FILING NO. 4  
ROADWAY & STORM IMPROVEMENT PLANS

TRAILS AT ASPEN RIDGE			
FILING NO. 4 ROADWAY & STORM IMPROVEMENT PLANS			
ROADWAY PLAN & PROFILE			
DESIGNED BY:	CAG	SCALE	DATE ISSUED:
CHECKED BY:	NMS	HORIZ 1"=40' VERT. 1"=8'	JUNE 2021
SHEET			5 OF 32
RD01

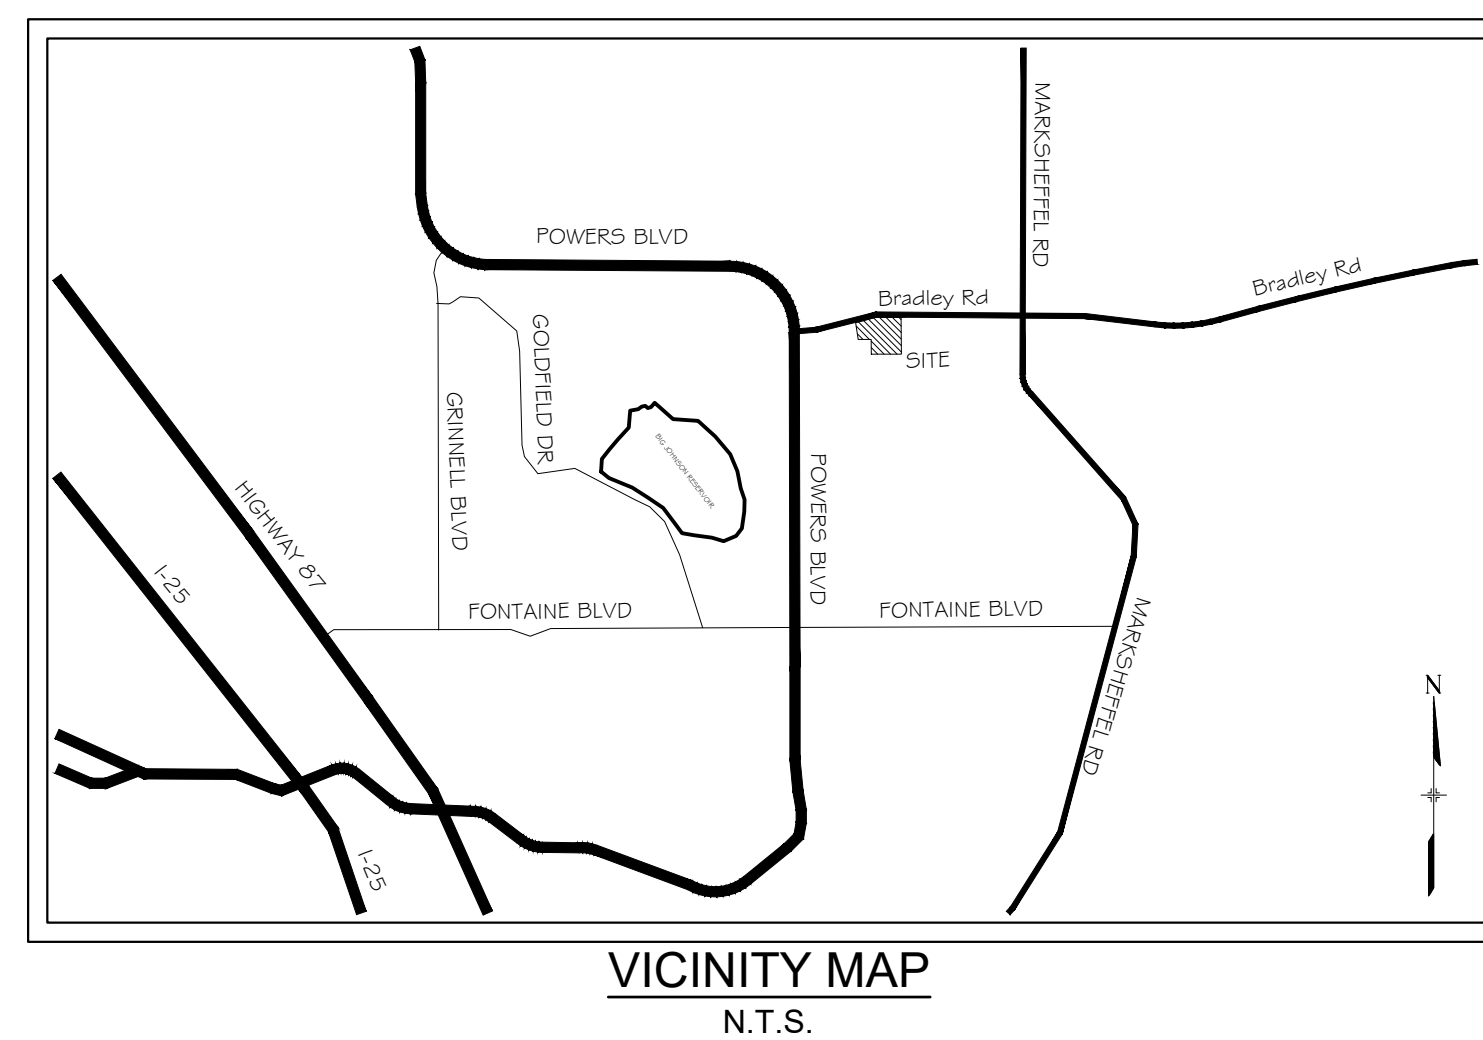
Include the water and sanitary sewer plans or upload as a separate utility construction documents for review and approval.

DRAWING No. GN02

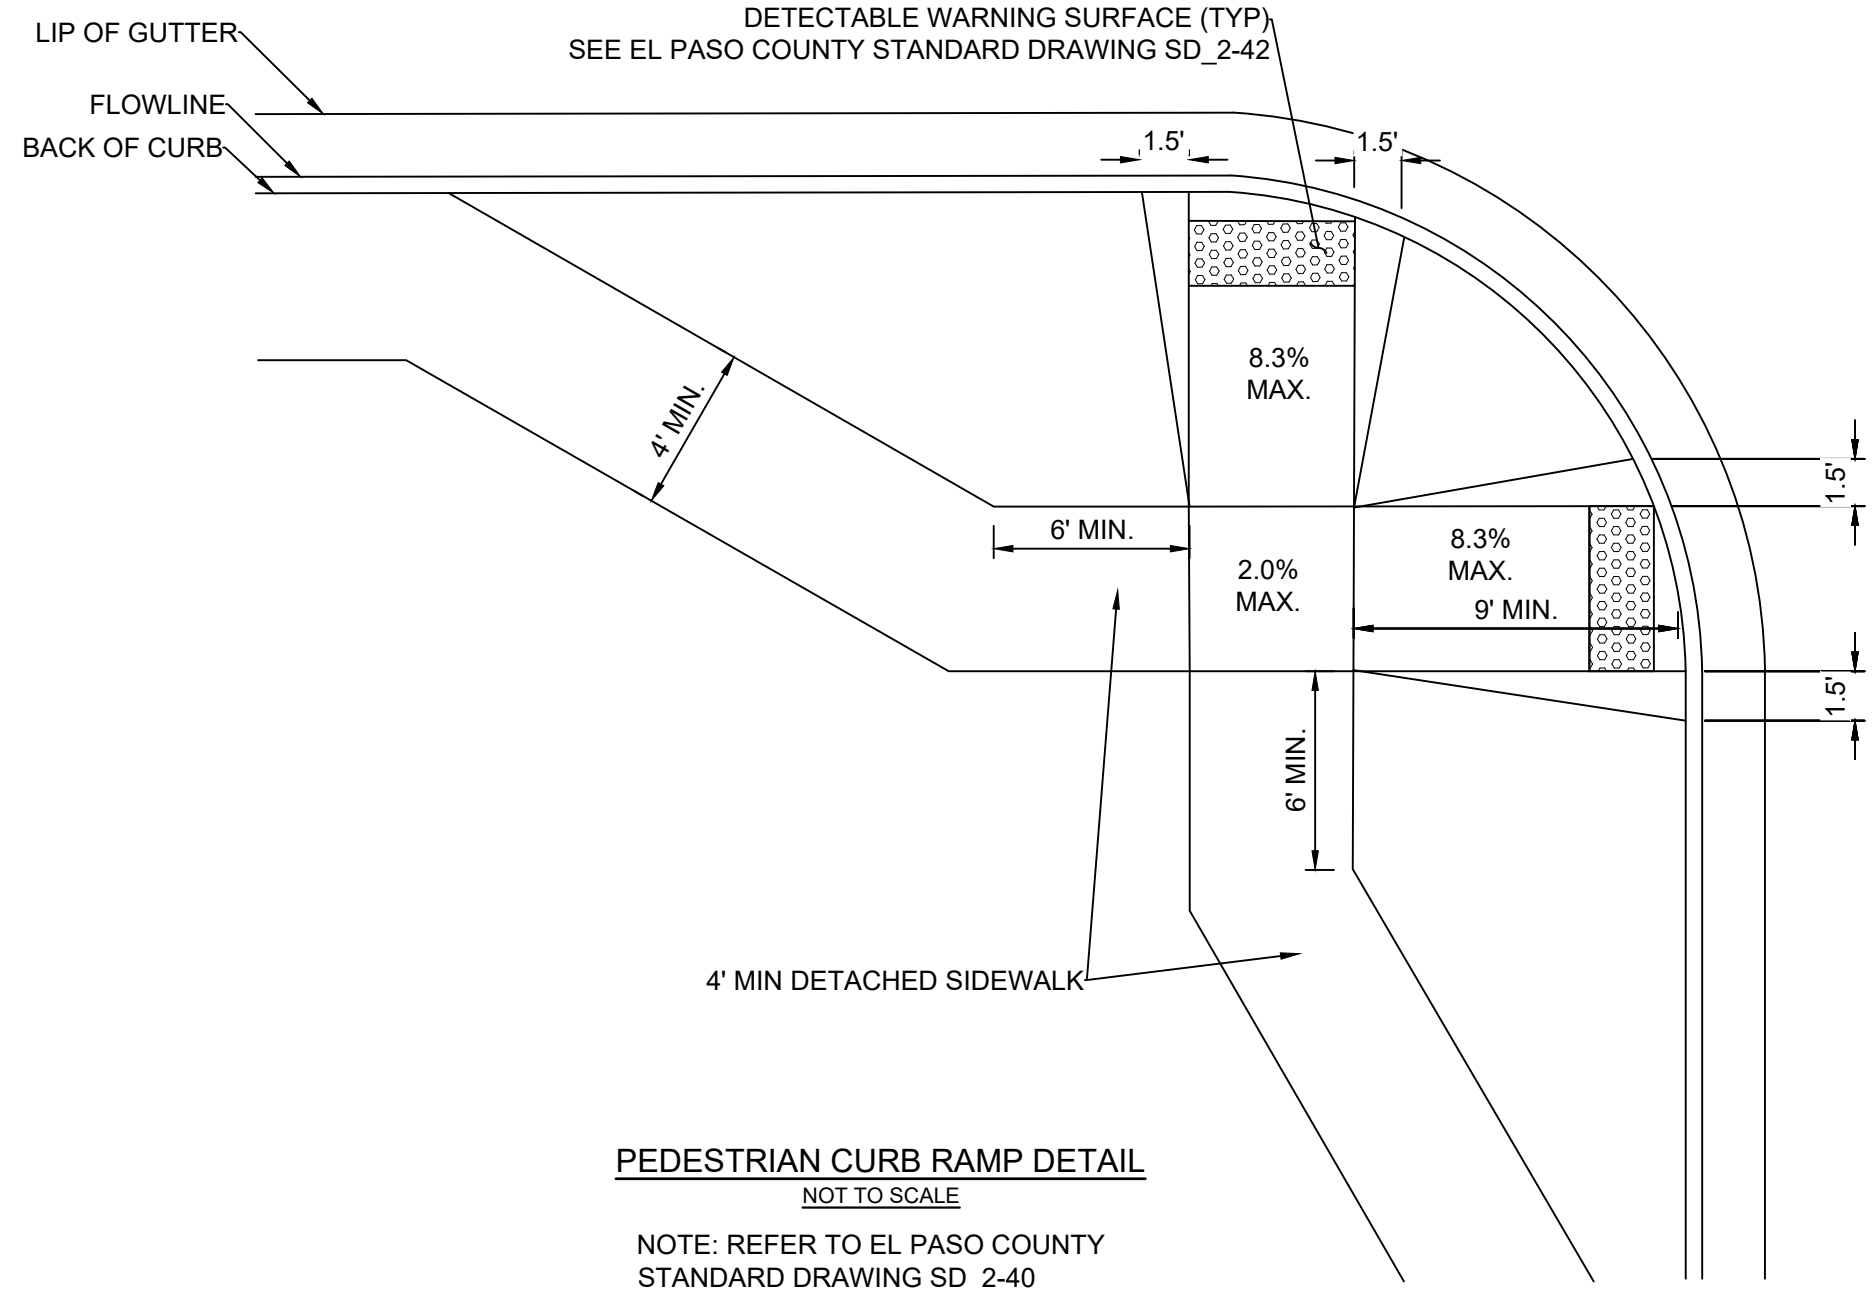
Add the notes from detail SD\_2-26

revise to 14"

TRAILS AT ASPEN RIDGE			
FILING NO. 4 ROADWAY & STORM IMPROVEMENT PLANS			
STORM KEY MAP			
DESIGNED BY:	JTS	SCALE	DATE ISSUED:
DRAWN BY:	BAS	HORIZ. 1" = 80'	JUNE 2021
CHECKED BY:	NMS	VERT. N/A	SHEET
23 OF 32			DRAWING No. SD00

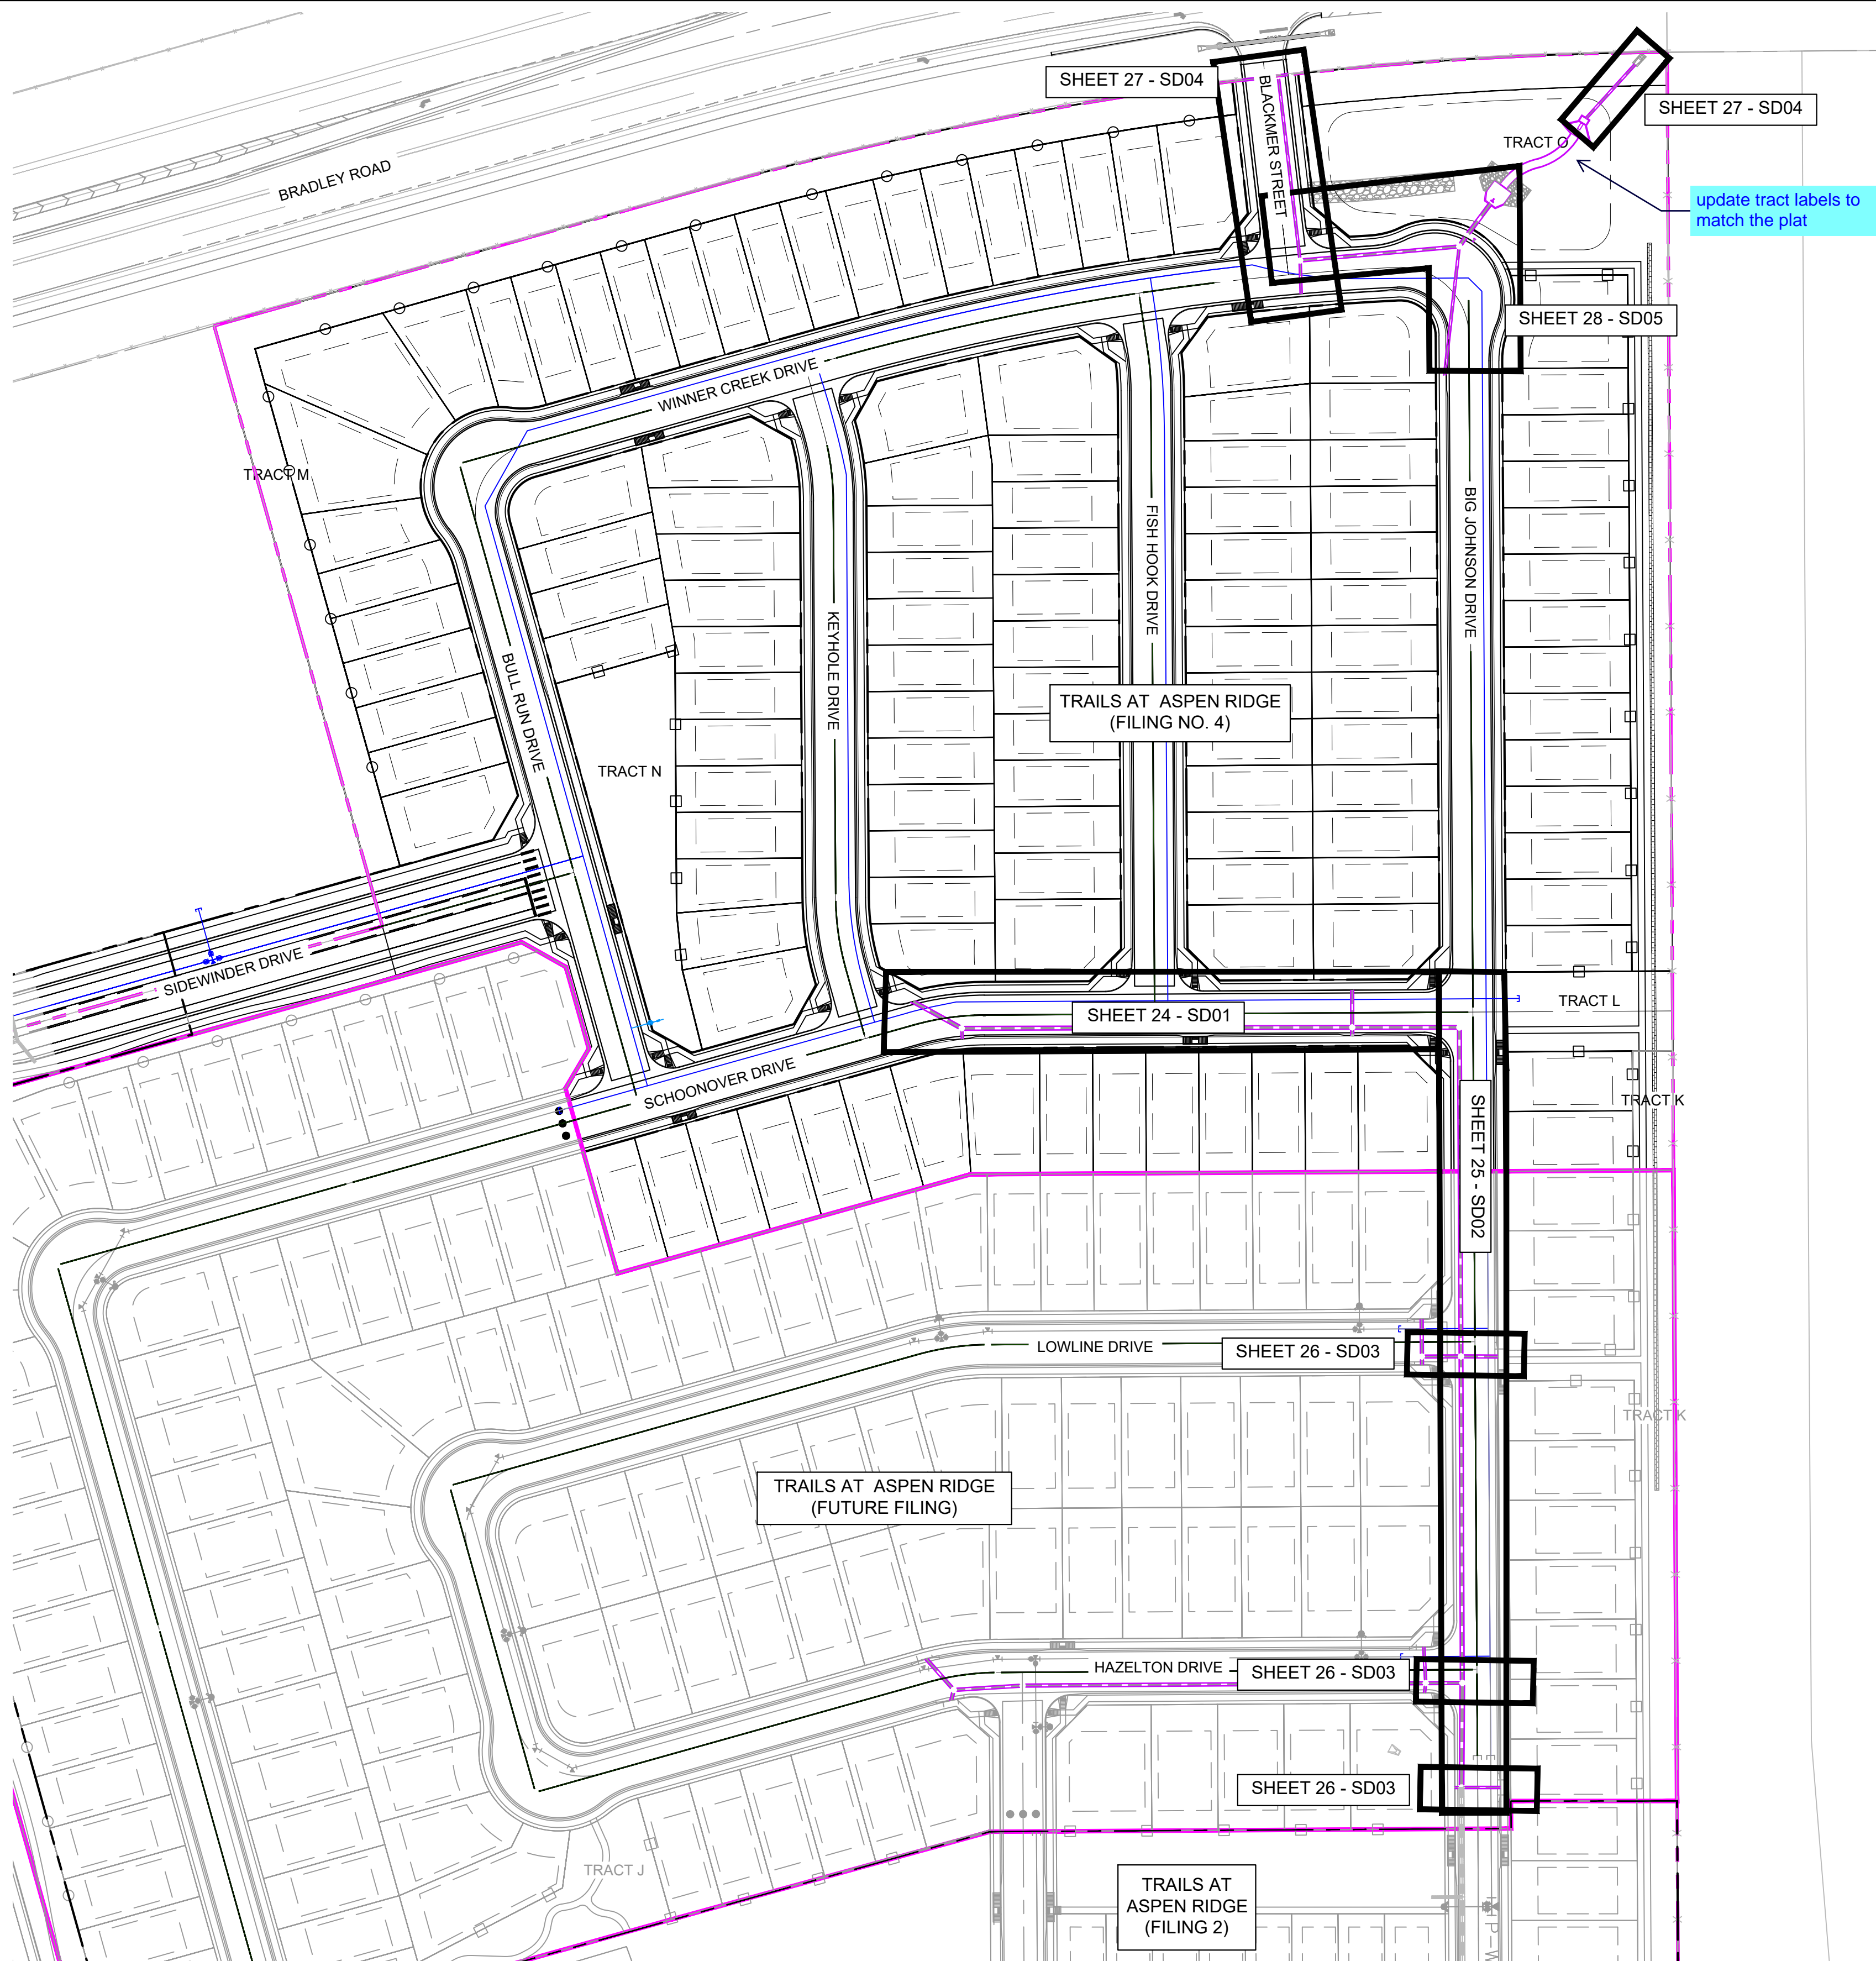
update tract labels to match the plat
